Bid Bulletin #02

PROJECT: Weeping Water Public Schools
Additions & Renovations
Weeping Water, NE

RE: Addendum No. 1 to the Bidding Documents for:
Weeping Water Public Schools
Additions & Renovation
204 West O Street
Weeping Water, Nebraska 68463
Schemmer Project No. 06368.001

This addendum consists of nine (9) pages of written addendum items and twenty-one (21) pages of supplemental drawings.

SHEET NO: SDA-1

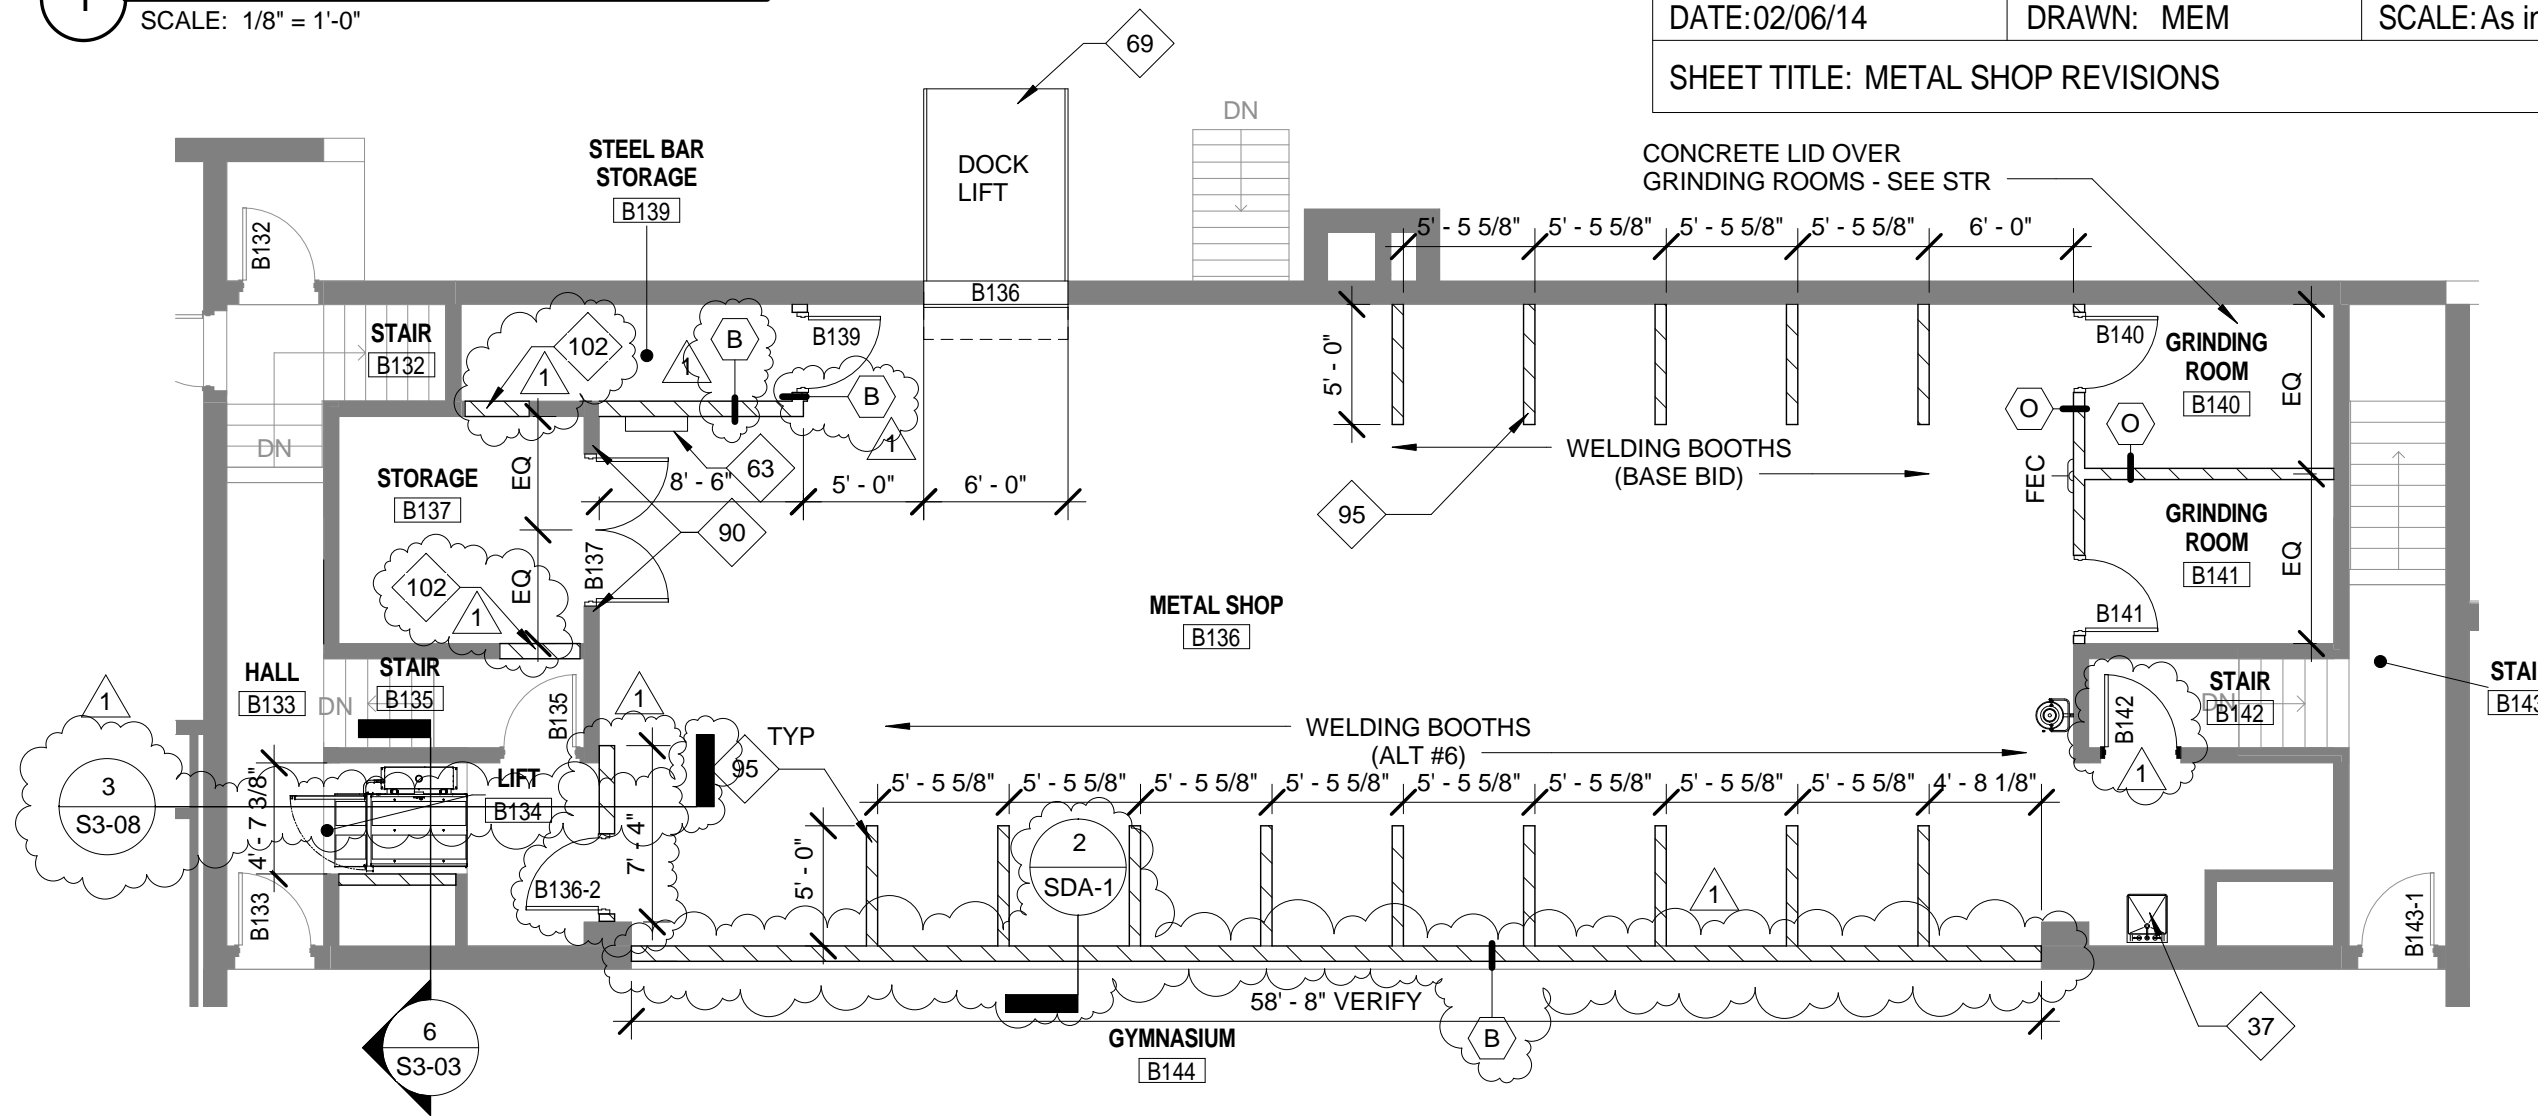
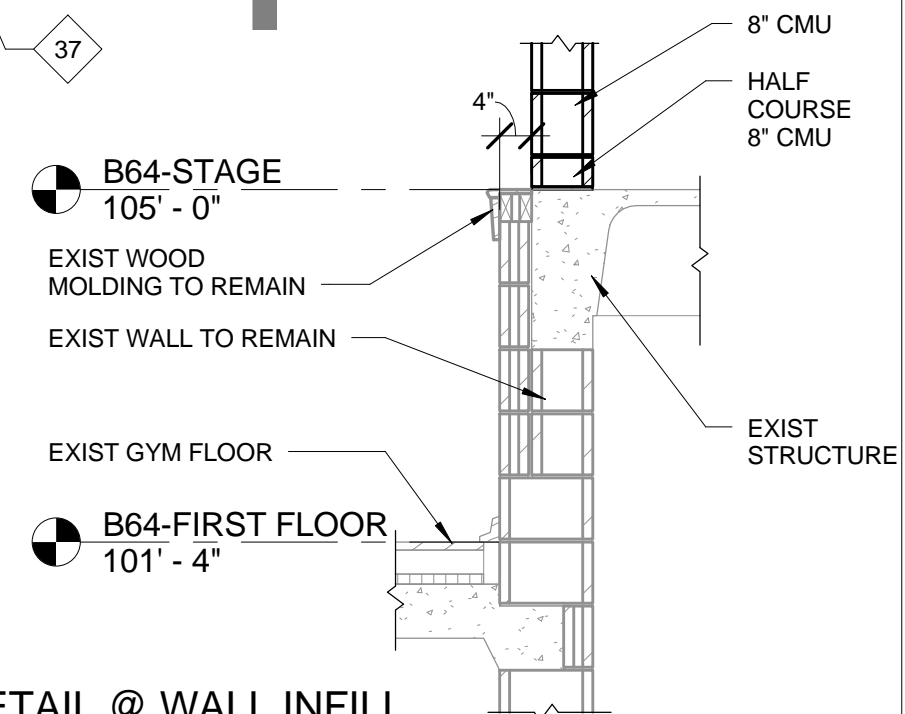
- 1) At IT B117, DELETE referenced plan note "#20" at south wall, ADD "#103" in its place.
- 2) At LANGUAGE B118, DELETE referenced plan notes "#39" at 2 locations on south wall and west wall location, ADD "#102" in their place.
- 3) At STORAGE B137, DELETE referenced plan notes "#20" at south and north walls, ADD "#102" in their place.
- 4) At GUIDANCE B151, DELETE referenced plan notes "#20" at east wall, ADD "#102" in its place.
- 5) At NURSE B155, DELETE referenced plan notes "#39" at north and east walls, ADD "#102" in their place.
- 6) ADD revisions on SDA-1, see attached.

- 1) Move 6" CMU infill wall between GYMNASIUM B144 and METAL SHOP B136 4" to the North, see SDA-1 attached.

- 1) DOOR SCHEDULE – LOWER LEVEL – AREA C
 - a. Door No. C001-2, DELETE hardware Set No. “8”, ADD Hardware Set No. “2”.
 - b. Door No. C004, ADD “60 minute label to door and frame”.
- 2) DOOR SCHEDULE – FIRST FLOOR – AREA A
 - a. Door No. A133-1, ADD hardware Set No. “29”.
 - b. Door No. A133-3, ADD hardware Set No. “29”.
- 3) DOOR SCHEDULE – FIRST FLOOR – AREA B
 - a. DELETE “RLRL” from first column. ADD “DOOR NO.” in its place.
 - b. ADD revisions on SDA-1, see attached.

SHEET NO: SDA-3

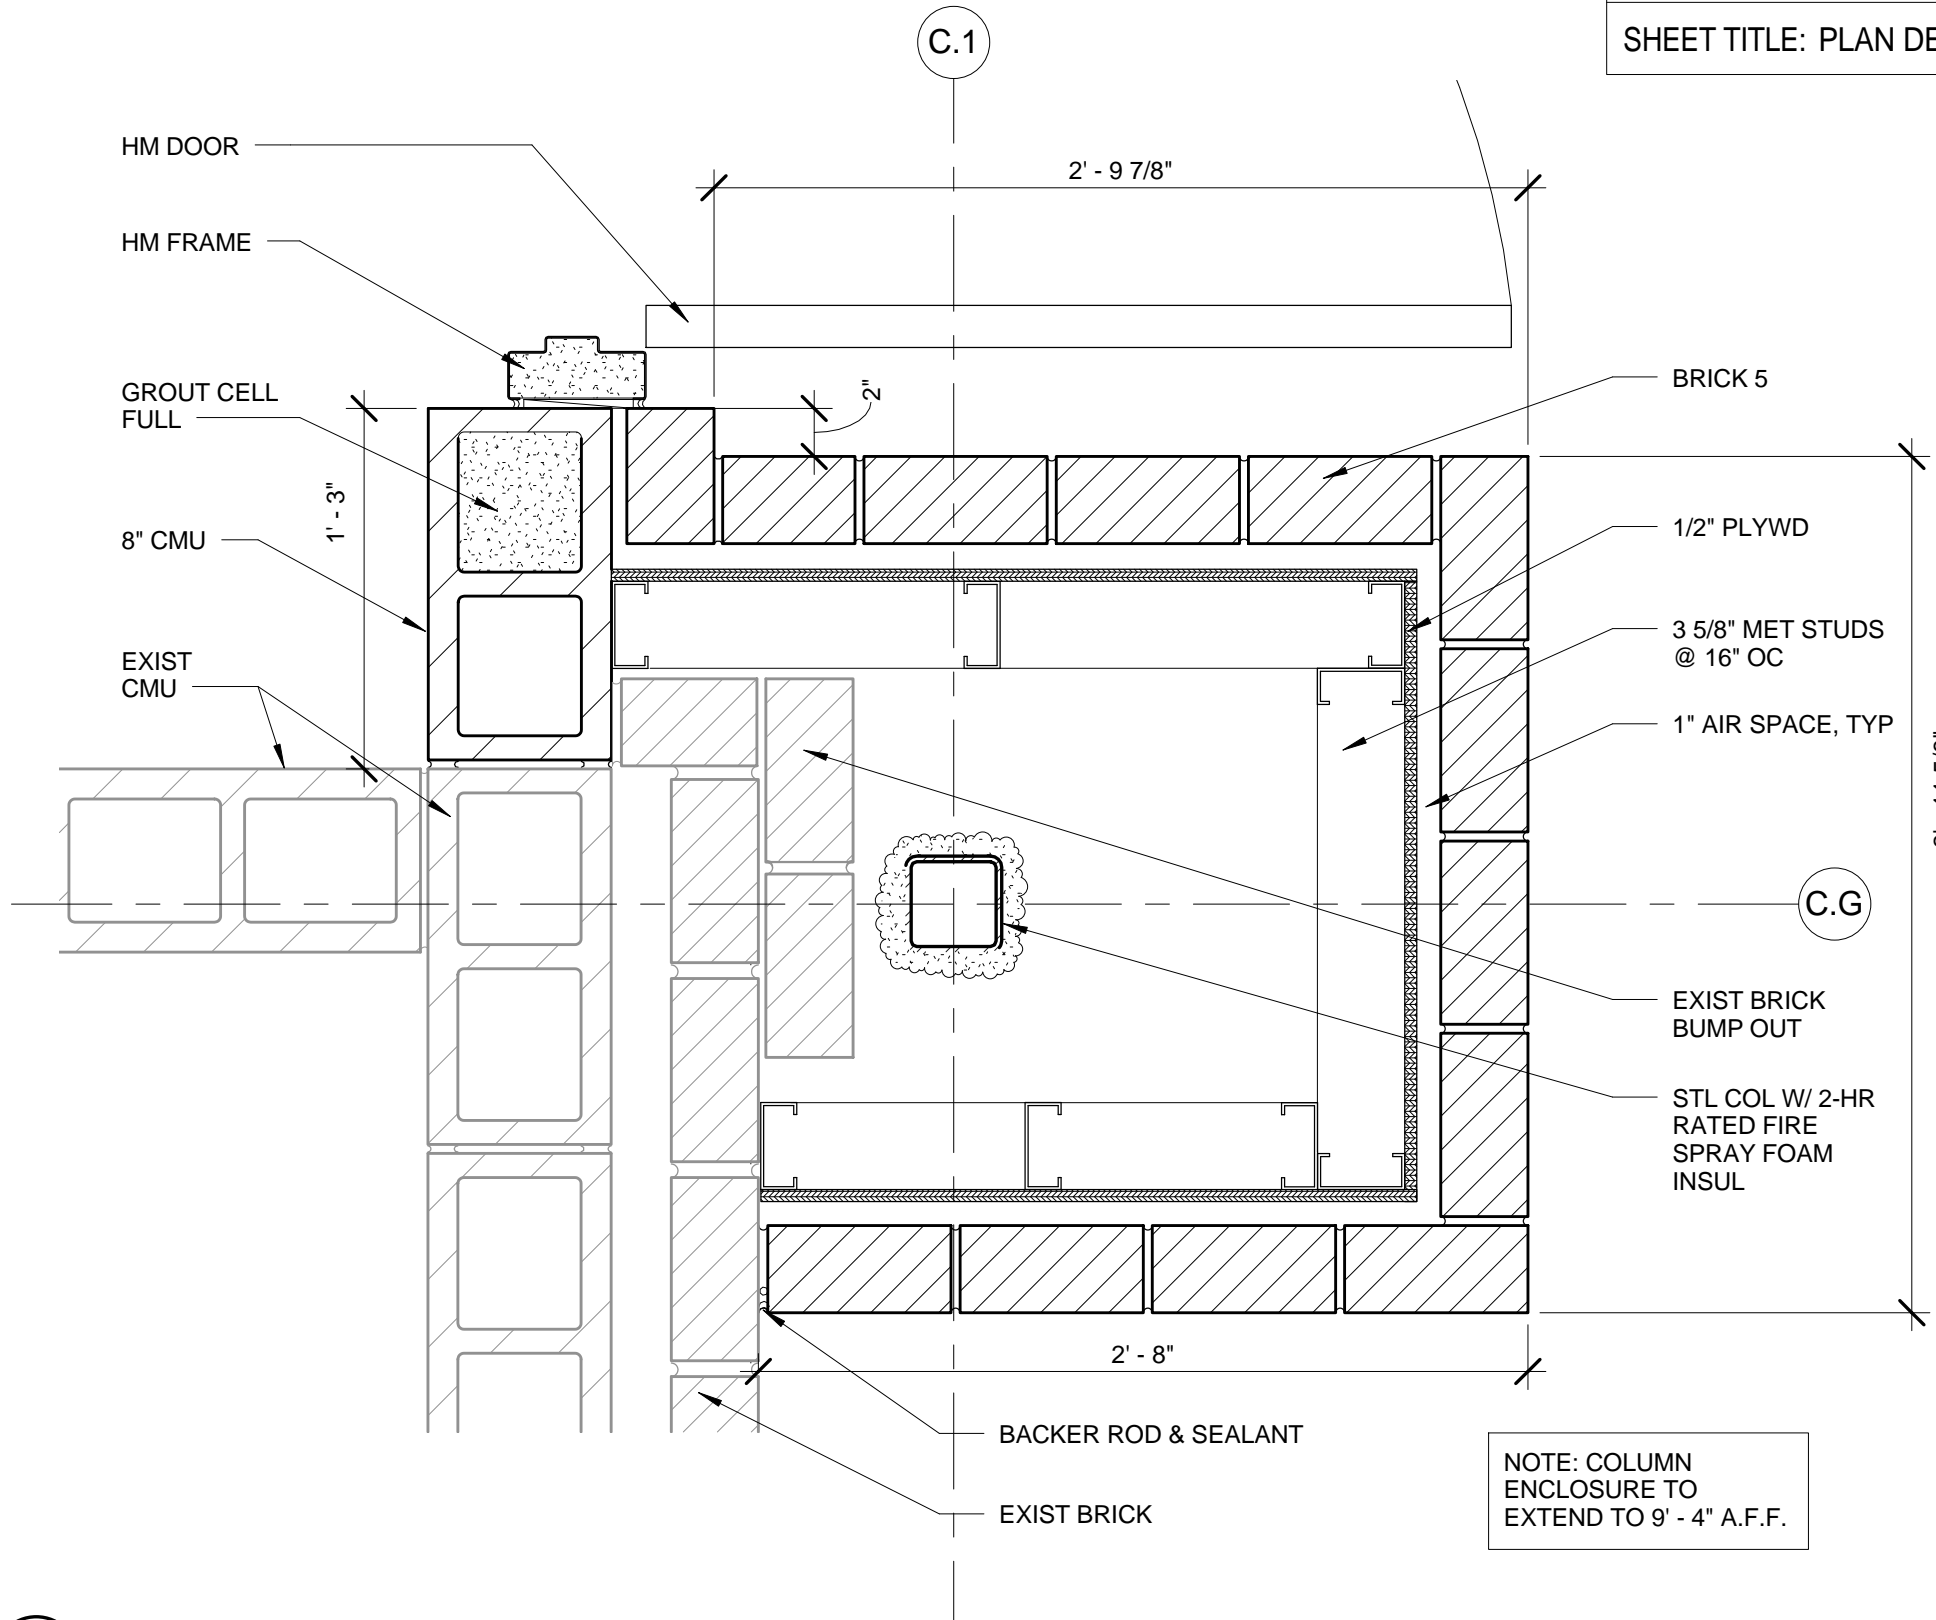
- 1) Details 1, 5, 6, & 7
 - a. REMOVE "BRICK 1". ADD "BRICK 5" in its place.
 - b. ADD NOTE "ENCLOSURE SHALL EXTEND TO 9' - 4" A.F.F."
- 2) Detail 2
 - a. REMOVE "BRICK". ADD "BRICK 3" in its place.
- 3) Detail 4
 - a. REMOVE "FACE BRICK". ADD "BRICK 2" in its place.
- 4) REMOVE detail 6, ADD SDA-3 in its place, see attached.
- 5) ADD detail 8, see SDA-2 attached.

SHEET NO: SDA-4

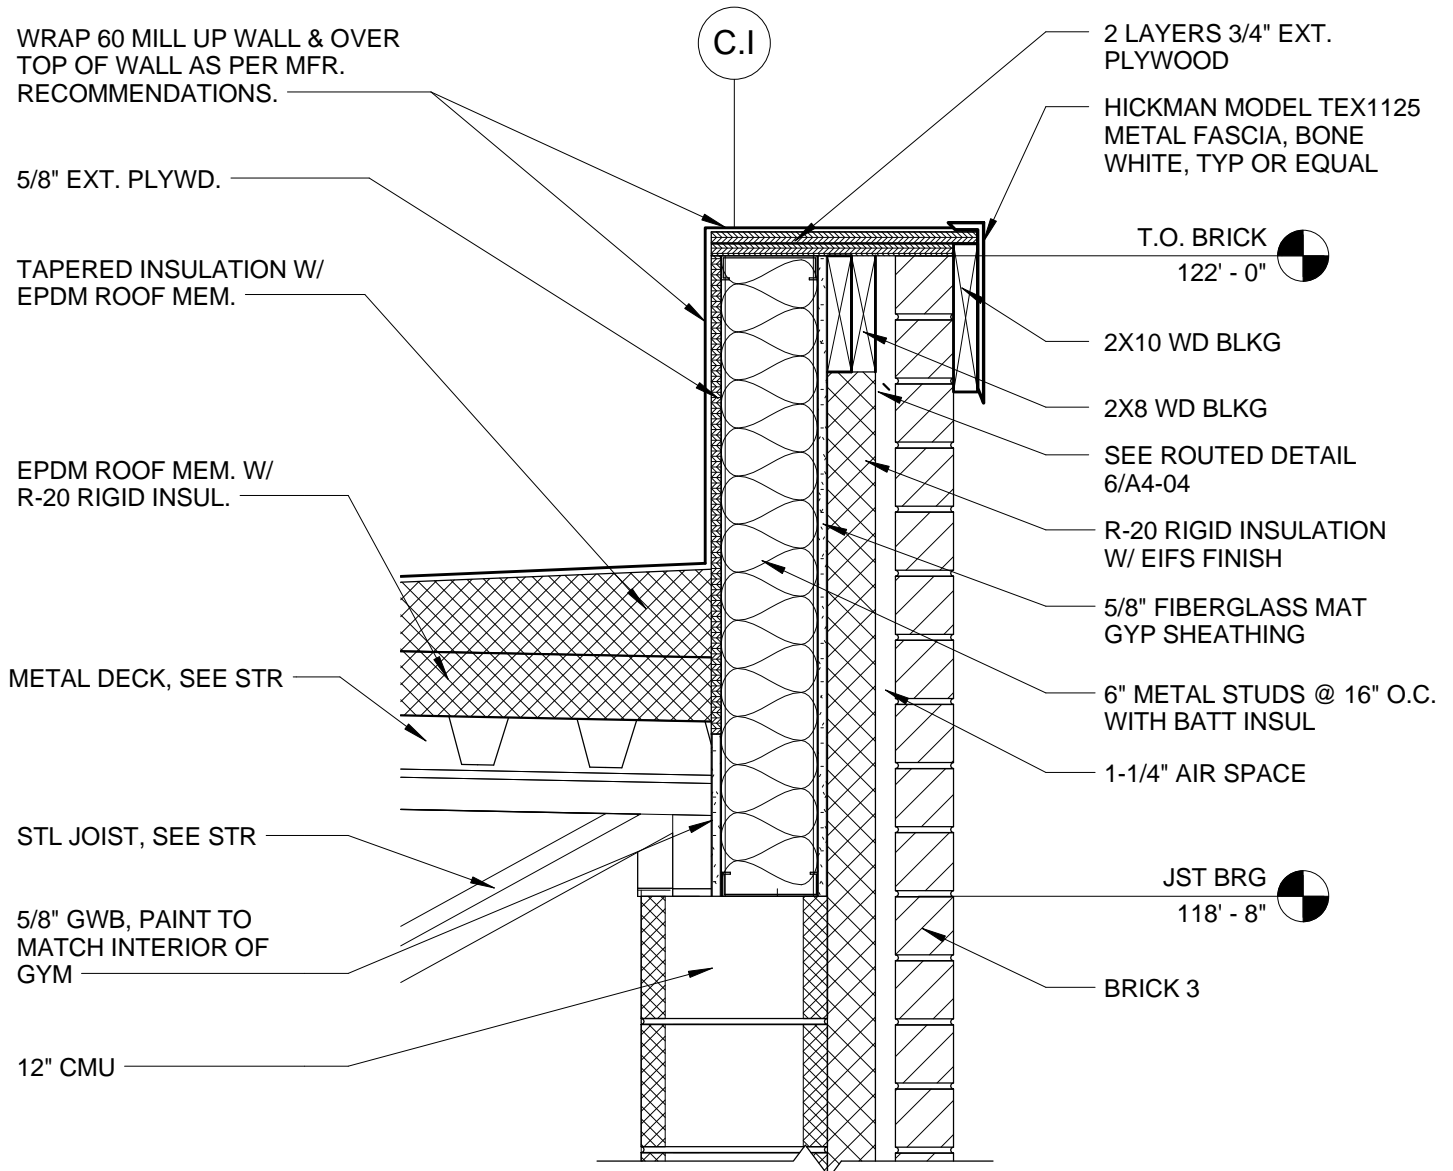
- 1) Detail 4
 - a. DELETE "SEE ROUTED DETAIL X/XX/XX". ADD "SEE ROUTED DETAIL 6/A4-04" in its place.
- 2) ADD detail 7 on SDA-4 attached.

SHEET NO: SDA-5

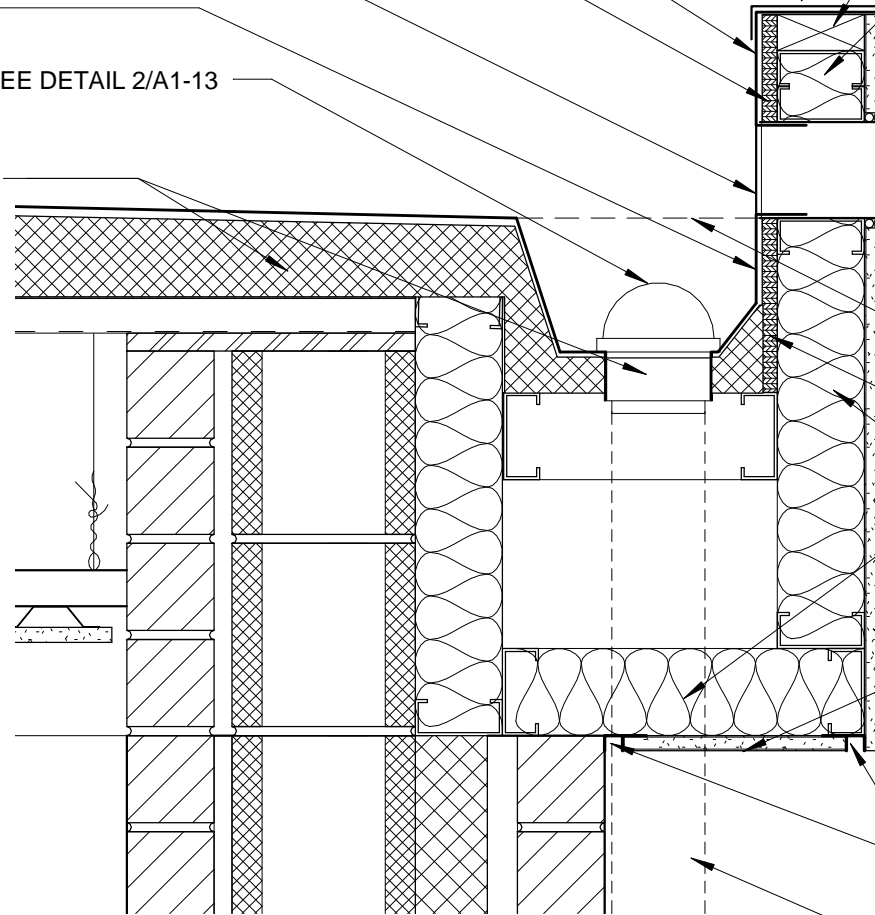
- 1) Wall Section 2
 - a. DELETE referenced callout “5/A4-04 SIM”. ADD “7/A4-12” in its place.
- 2) Detail 3
 - a. DELETE, ADD SDA-5 in its place. See attached.

EPDM MEMBRANE, WRAP
OVER SCUPPER ASSEMBLY
UP UNDER CAP FLASHING

WHERE EXT PLYWOOD IS
CONTINUOUS, WRAP
EPDM MEMBRANE UP
UNDER CAP FLASHING

EPDM MEMBRANE, WRAP ALONG
GUTTER AND INTO SCUPPER
ASSEMBLY

4-1/2" ROOF DRAIN, SEE DETAIL 2/A1-13
